**Halifax**

**RFT# 4263**

**Boiler Replacement, Gym Heat Pumps,  
and Controls Upgrades  
Caudle Road Elementary School  
Addendum #2**

**ASPHALT SURFACE**

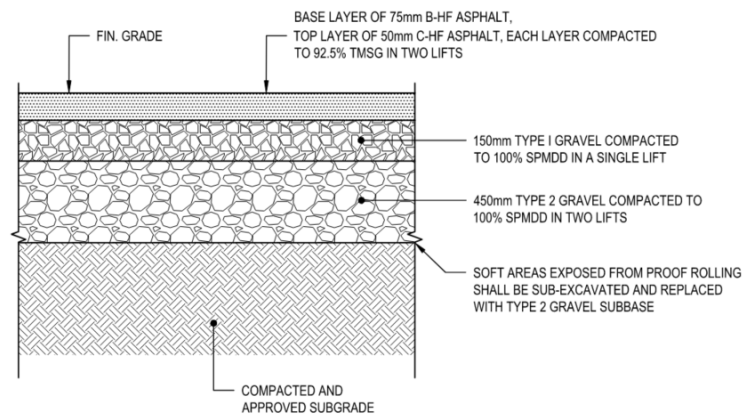
-1.1.4. Optional Scope 4: Reconstruction of Parking Lot:

-1.1.4.1 General extents of the scope of work to match the extent described in Optional price 3.

-1.1.4.2 Provide for removal of the existing asphalt and sub-base material as needed to restore to grade level with the newly specified section below.

-1.1.4.3 Provide for reconstruction of the parking lot with the construction cross-section presented below:

1. THICKNESSES SHOWN ARE MINIMUM. IF EXISTING ROAD STRUCTURE EXCEEDS THESE, MATCH EXISTING.
2. SUBGRADE TO BE INSPECTED AND APPROVED BY A GEOTECHNICAL ENGINEER.
